RESPONSE TO PEER REVIEW COMMENTS

A methodology for *Voluntary Emission Reductions in Rice Management Systems* was developed by Terra Global Capital, with support from the Environmental Defense Fund, Applied Geosolutions and the California Rice Commission, and submitted to ACR for approval through the public consultation and scientific peer review process.

This document provides three additional rounds of review, of methodology revisions including the addition of early drainage as an eligible practice, new additionality language related to early adopters, clarified definitions, and more specific guidance on verification.

Appendix: graph of late-season vs. main-season modeled vs. measured emissions

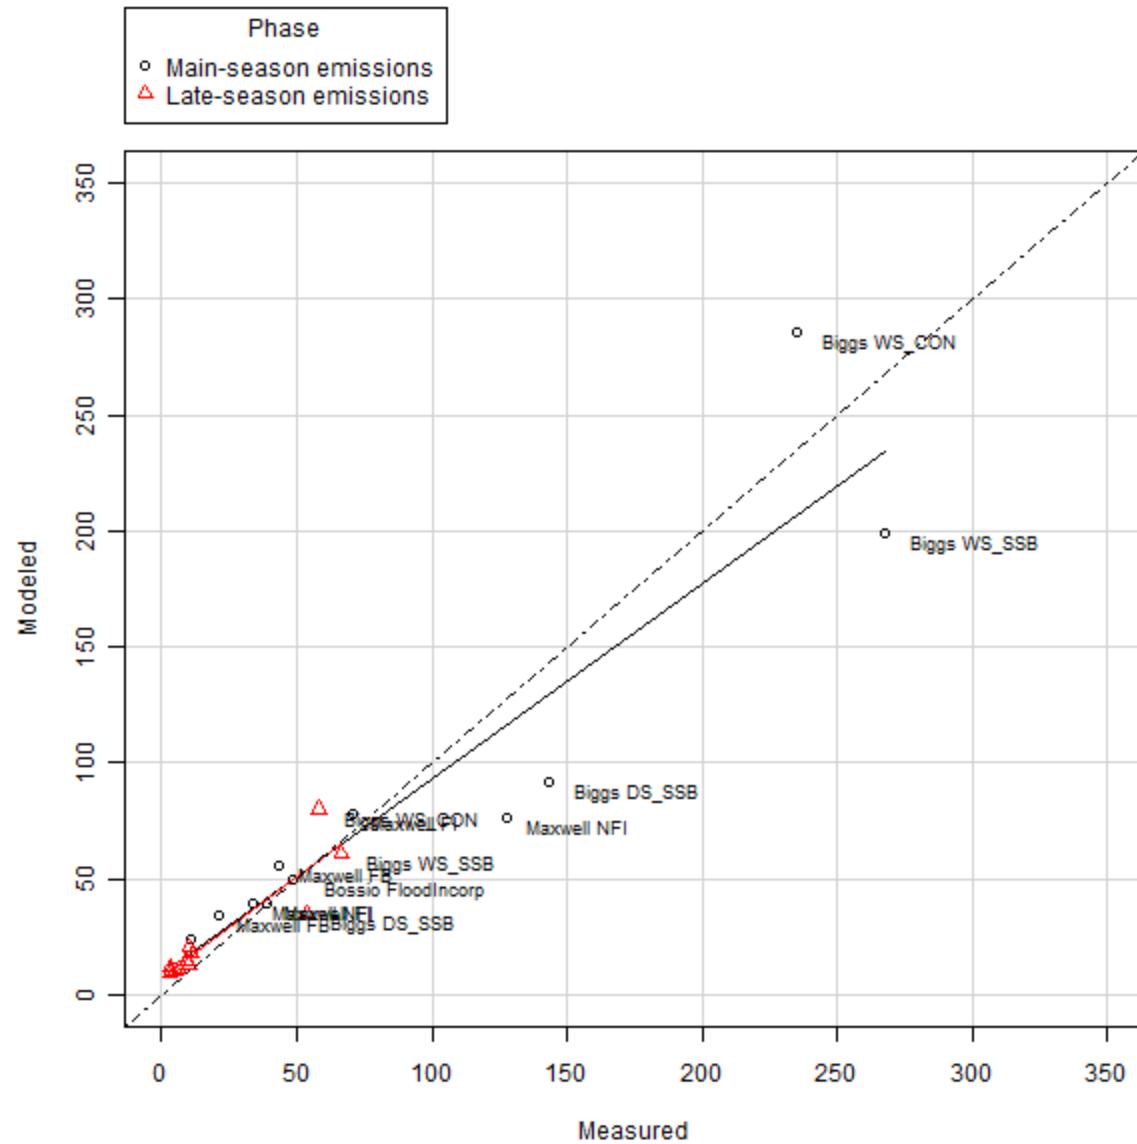
1st review	Response	2nd review	Response	3rd review	Response
1	I am personally not in favor of using this as a mitigation strategy for the following reasons: 1. There have been no studies conducted to support the fact that CH ₄ emissions are actually reduced when fields are drained early. While it may make some	We conducted a careful analysis of late-season emissions (i.e., within 14 days of harvesting) vs. main season emissions. Our analysis indicated that there was absolutely no difference in DNDC’s ability to simulate emissions between these two phases. We conclude that DNDC can be used effectively to predict emission	Accepted.	n/a	n/a	n/a

This appendix is presented in support of the authors response to comment #1 under Comments on ACT3, Early Drainage. We provide a graph of modeled vs. measured fluxes for both main-season emissions (black points and regression line) and late-season emissions (red points and regression line). Late season is defined as three weeks before harvest. Values are in kg C ha⁻¹ yr⁻¹. Points above 25 kg C ha⁻¹ yr⁻¹ are labeled with the Site and Treatment Code. A description of each Treatment Code is summarized below.

One can observe that there is no difference in the regression line of modeled vs. measured values for either main-season or late-season emissions. Obviously, the late-season emissions, which are accumulated over only 3 weeks, are much smaller in magnitude than the main season emissions, which are accumulated over several months. Therefore, it is concluded that there is no evidence that the DNDC model is biased later in the growing season when fluxes are summed over 2-3 weeks. Note that this does not necessarily mean that daily fluxes are unbiased.
